Section 1 – General Components and Comments

After the Sunrise Powerlink Project was approved by the CPUC in December 2008 and the BLM in January of 2009, SDG&E began the process of completing final project design and engineering. On May 14, 2010, SDG&E submitted its Final Project Modification Report (PMR) to the CPUC and BLM. The PMR defines changes made to the project as a result of mitigation requirements or federal and State regulations along the Sunrise Powerlink Transmission Project route after publication of the Final Environmental Impact Report/Environmental Impact Statement (EIR/EIS).

1.1 Revised Project Components

Model Results Within Firesheds
 1. Total Acres Burned = 192,595 Acres
 2. Assets At Risk 1,396 Residential Parcels

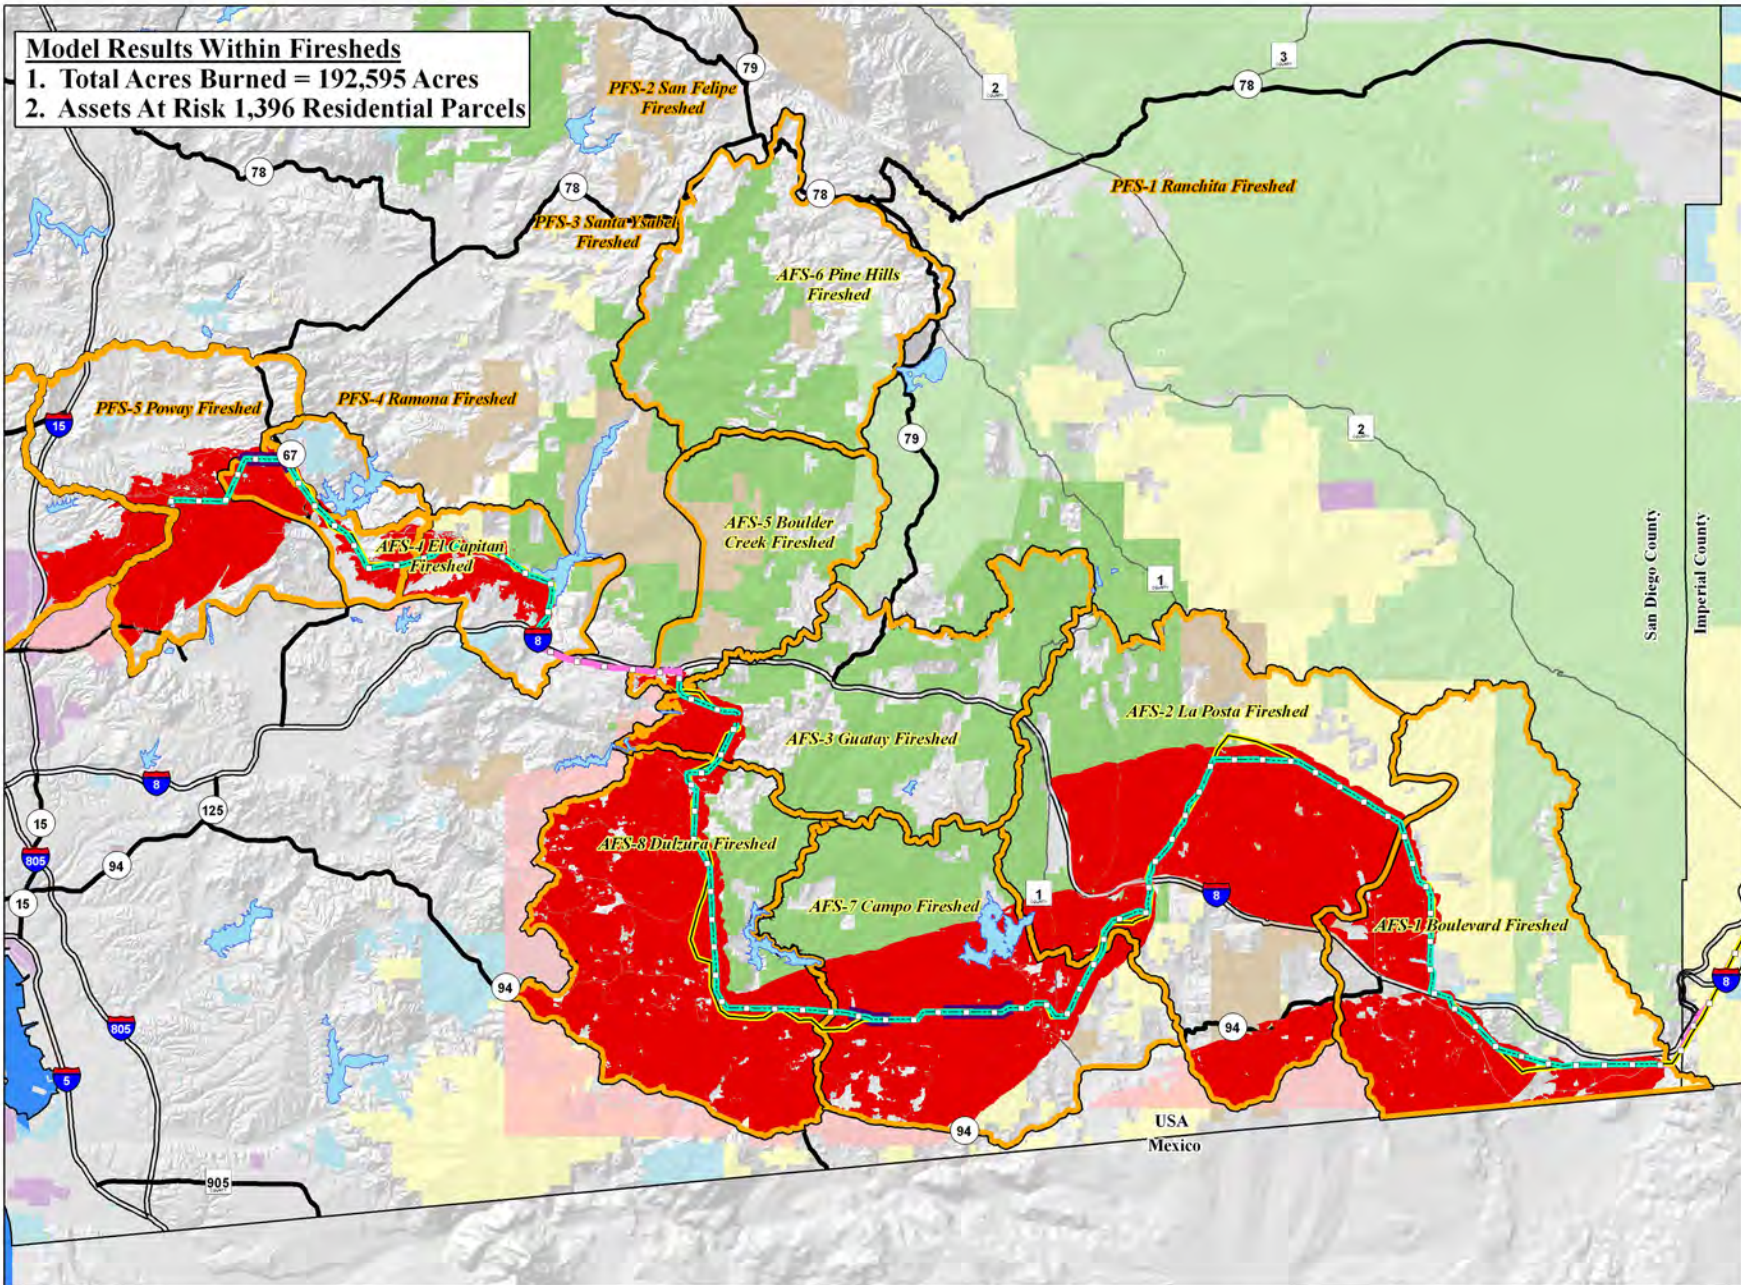
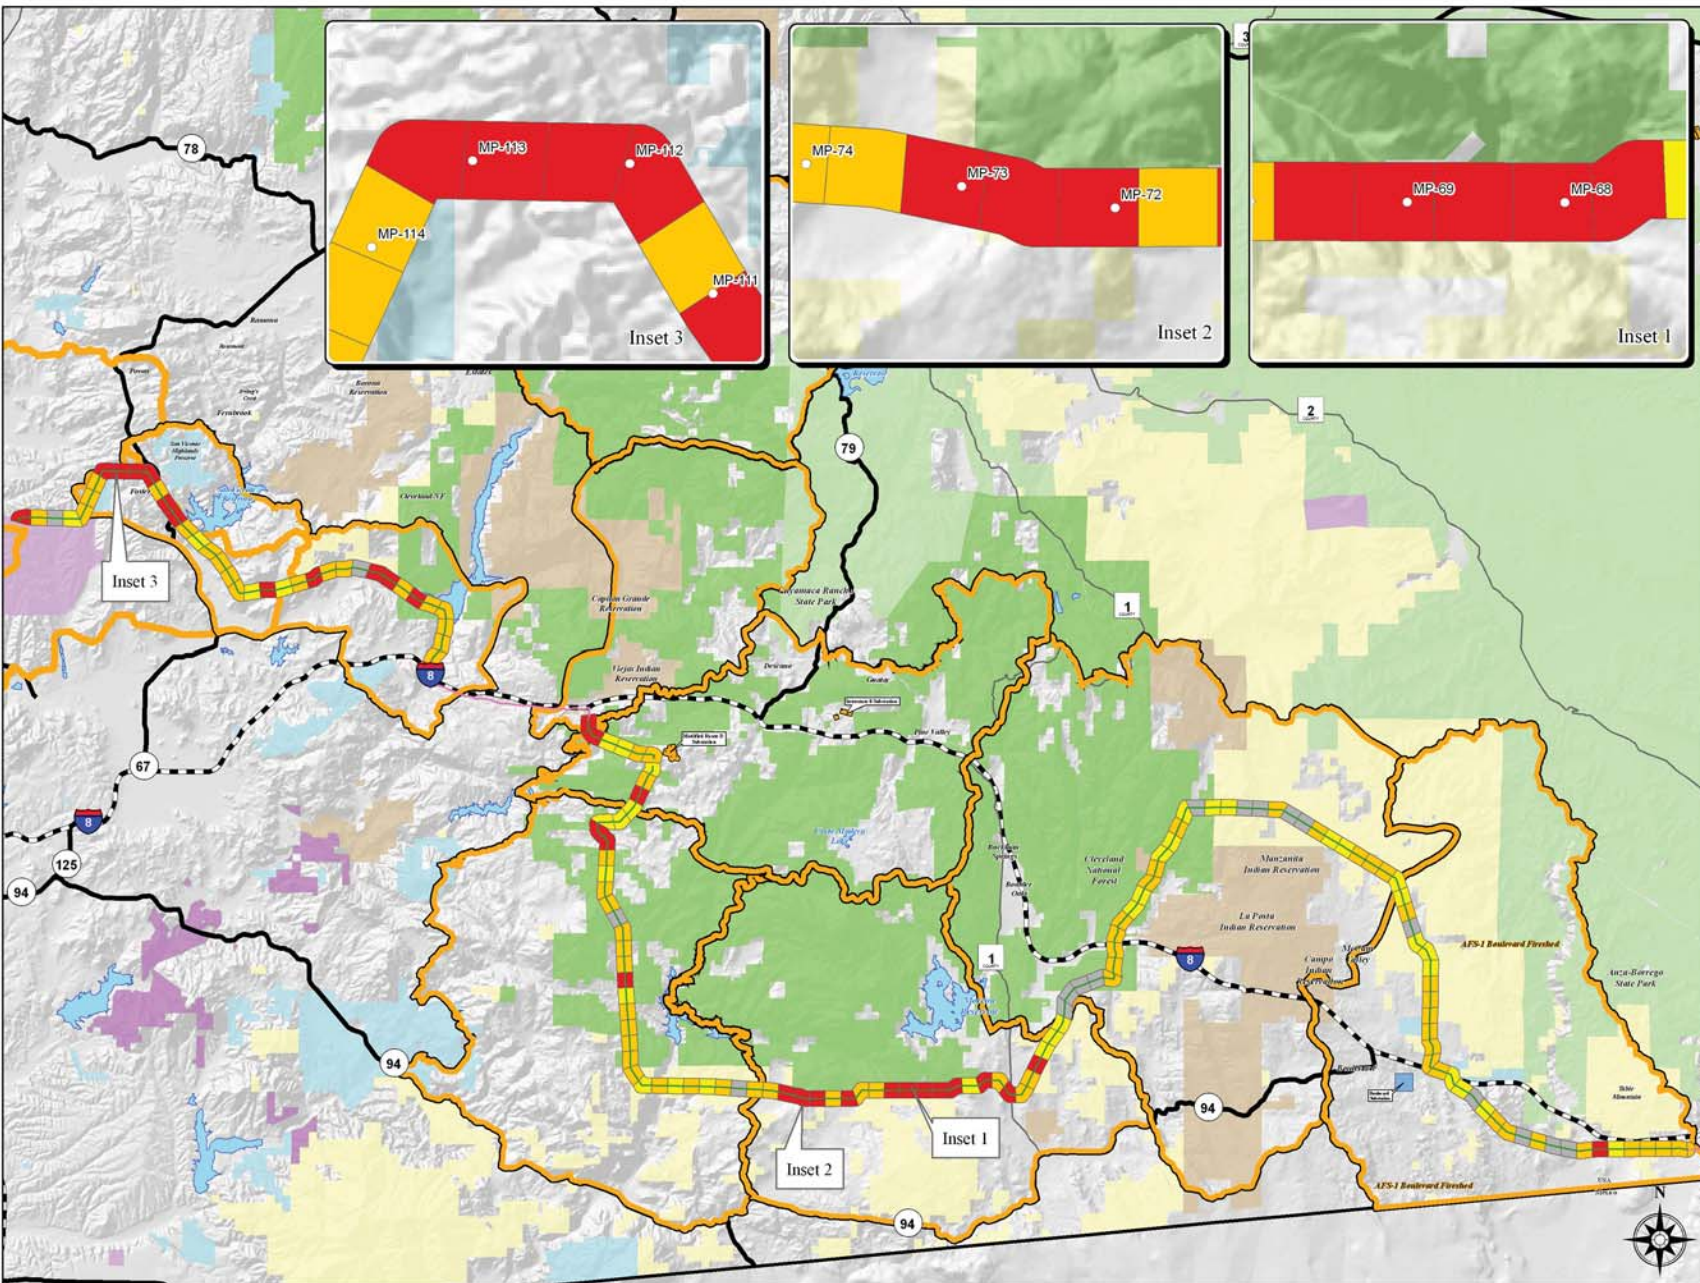
Project Firesheds and Fire Behavior Modeling in the EIR/EIS. The County of San Diego Department of Planning and Land Use commented on the approach taken in the EIR/EIS to model wildfire behavior, suggesting that the EIR/EIS underestimates the extent of a major wildfire event in San Diego County. Although wind-driven wildfires in San Diego County have the tendency to be larger than the potential burn areas shown in the Fire Behavior Trend Modeling analysis, the EIR/EIS analysis was confined to the project study area, defined as the project firesheds in the EIR/EIS. This approach is addressed in General Response GR-9, Fire Risk and the Comparison of Alternatives: Fire and Fuels Modeling in the Final EIR/EIS. As stated in General Response GR-9, the fire models presented in the EIR/EIS are based on defensible assumptions and a uniform protocol, and any modifications to the modeling inputs would introduce bias into the results. The protocol and assumptions are explained in detail above, and it is demonstrated that, although actual wind-driven wildfires in San Diego County may be smaller, larger, or

Updating the Fire Models in Accordance with the Project Modifications. In accordance with the County's suggestion to update the Fire Behavior Trend Model and the homes at risk calculation, the EIR/EIS Team reprocessed both the Fire Behavior Trend Model and the Wildfire Containment Conflict Model, and tallied the number of homes at risk and the number of significant miles of conflict for the project modifications. The results are presented here and in the figures entitled "Final PMR Route Overhead Portion Fire Behavior Trend Model, 4 Burn Periods – Extreme Weather" and "Final PMR Route – Overview Wildfire Containment Conflict Model" (figures are presented at the end of Section 1).

The number of homes at risk for the project modifications increased from 1,382 homes, as presented in the Final EIR for the FESSR, to 1,409 homes. This 2 percent increase in the number of homes at risk is

within the margin of error of the Fire Behavior Trend Model (+/- 2 to 3 percent⁷), and does not result in an actual increase in the absolute number of homes at risk. The Fire Behavior Trend Model represents a worst-case-scenario of impacts, and the number of homes at risk as modeled for the modified route does not represent an increase in an existing significant impact or a new significant impact of the FESSR. In order to err on the side of increased safety for residents in the vicinity of the modified route, the higher number of homes at risk (1,409) will be used to calculate the total annual value of the Defensible Space Grants Fund per Mitigation Measure F-1e. Damage or loss of the 1,409 WUI homes at highest risk in the event of a wildfire resulting from the Sunrise Powerlink project will therefore be partially mitigated by implementation of Mitigation Measure F-1e, the Defensible Space Grants Fund, which will ensure defensible space and fire-safe structural improvements to those homes at highest risk, although not to less than significant. This results in a Fund value of nearly \$3 million per year for the life of the project, which would ensure grants for defensible space and physical structure improvements to even more homes than what was required for the FESSR.

The number of miles of significant wildfire containment conflict decreased from 6.5 miles under the FESSR to 6 miles under the modified project.⁸ This is because the modified project would be two miles shorter than the FESSR and the realignment resulted in correspondingly shorter segments of significant conflict. However, the locations of significant wildfire containment conflict have not changed; see Final PMR Route – Overview Wildfire Containment Conflict Model. Because the locations of significant wildfire containment conflict have not changed from those identified by the model for the FESSR and because SDG&E has agreed to the calculation of fund value based on 6.5 miles of significant conflict, the amount of funds required for Mitigation Measure F-3a would not change. No substantial increase in a significant impact of the FESSR has been identified.
